REGULATION CHANGES FOR CONSULTATION

Committee:	Cross Country Committee
Date of meeting:	3 rd March 2020
Closing date for consultation:	22 nd May 2020
Email for comments:	crosscountryconsultation@motorsportuk.org

Section P Cross Country

Drawing Number 52

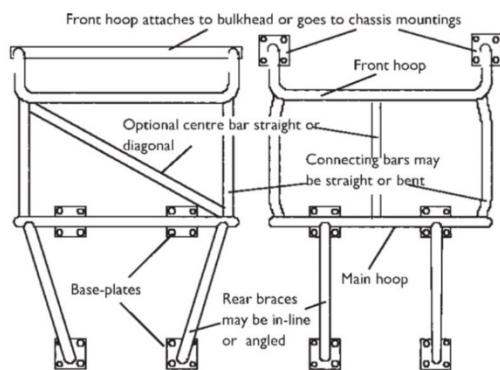
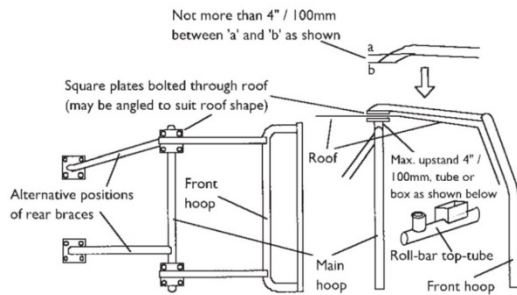
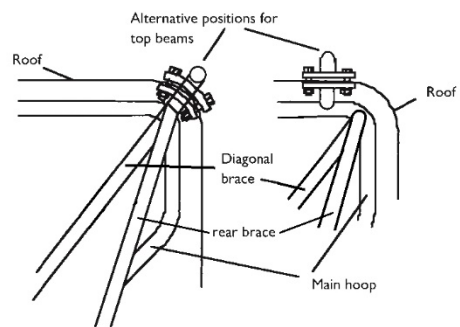
P56.14.8. The backstays where mounted directly to the chassis must be angled to the main roll hoop as shown in K Appendix 2, drawing 57. Existing vehicles configured with the backstays mounted in line with the main chassis members as shown in K Appendix 2, drawing 57 are permitted.

Drawing Number 52

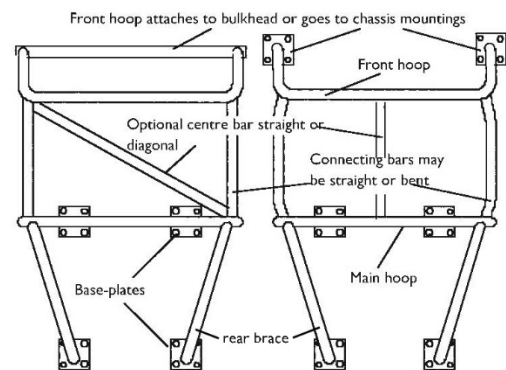
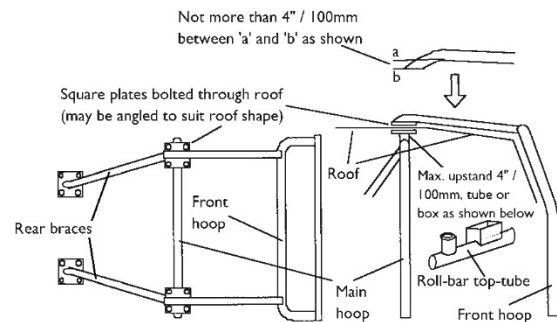
P56.14.8. The backstays where mounted directly to the chassis must be angled to the main roll hoop as shown in K Appendix 2, drawing 57. Existing vehicles configured with the backstays mounted in line with the main chassis members as shown in K Appendix 2, drawing 57 are permitted.

Reason: The provision for the ROPS rear stays to be fitted parallel to the chassis rails was to accommodate Land Rovers competing with the ALRC in Competitive Safaris, Hill Rallies and Point to Points. The ALRC withdrew this provision in 2014 and this proposal respects the stability regulations.
